**Re: University Station
Response to Stormwater Management Peer Review Comments**

Tetra Tech has completed our review of stormwater management peer review comments provided by BETA dated December 17, 2012. These comments are related to the November 30, 2012 submittal made to the Town. For ease of review, responses are numbered to coincide with the numbering system utilized in the original letter. Responses are shown in *italic* font.

Snow Storage Locations Plan

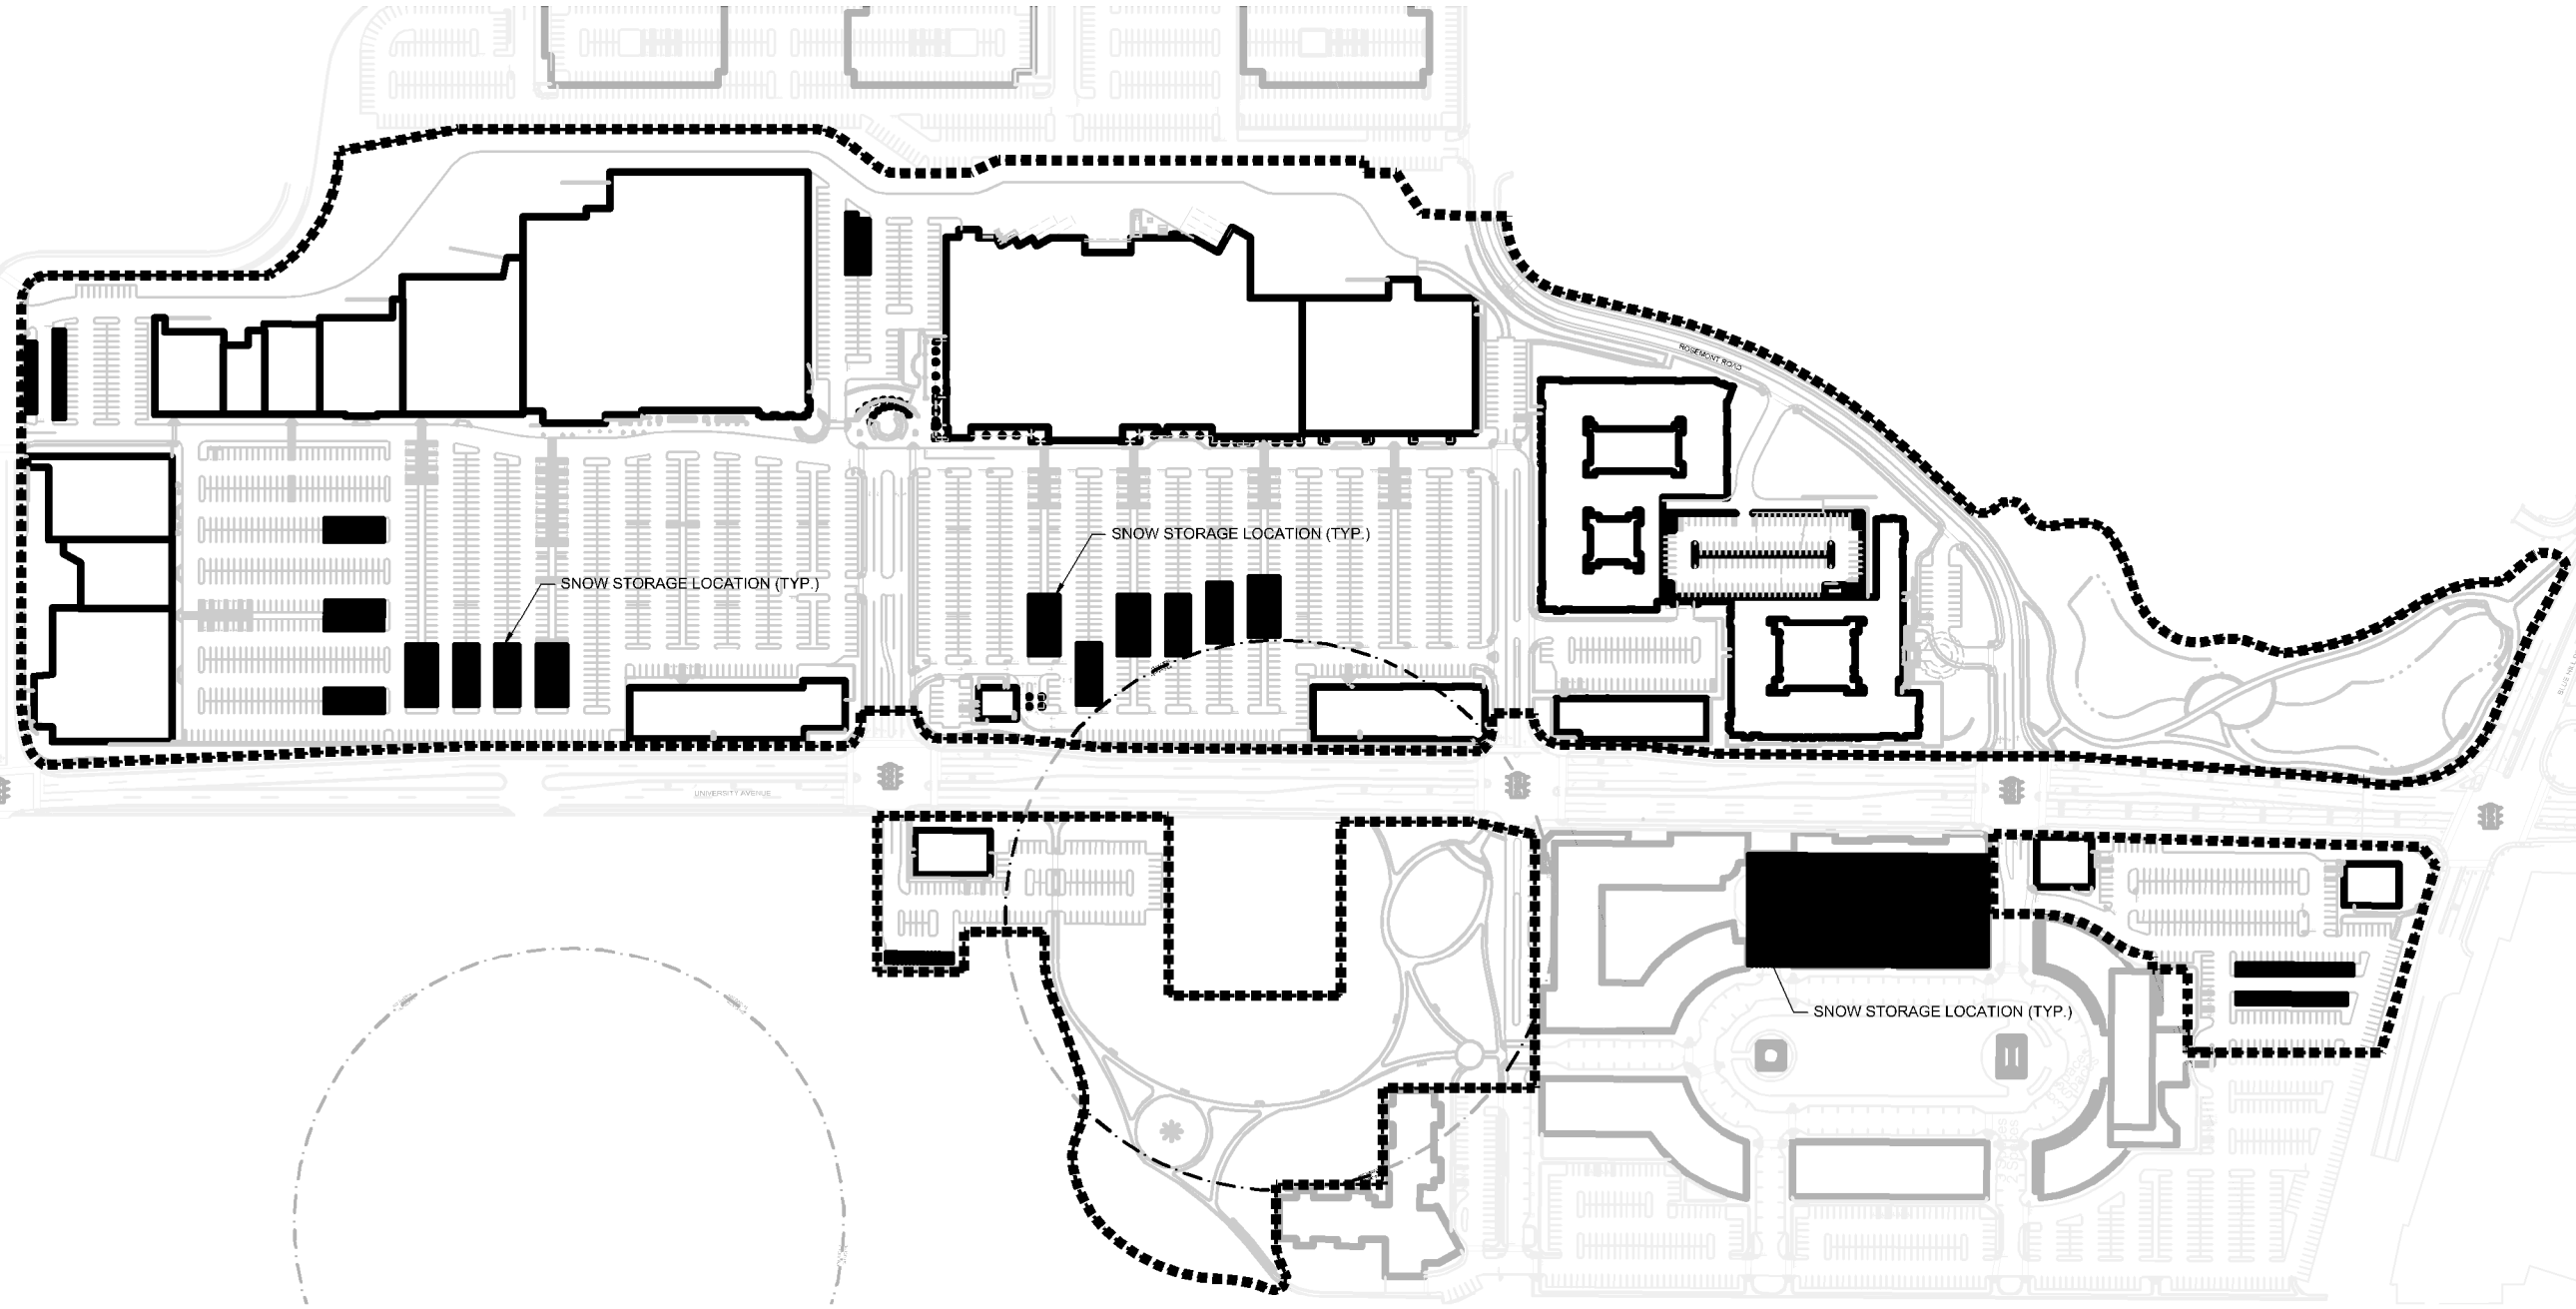
Show snow storage areas or document snow removal operation and maintenance plans.

Snow will be pushed to the bottom parking rows associated with the longitudinal landscaped islands or relocated to the undeveloped portions of the property east of University Avenue. Should parking demands require, snow will be removed to an off-site location.

At no time will snow be stored within the 400-ft Zone I Wellhead. A figure depicting snow storage locations is attached with this letter.
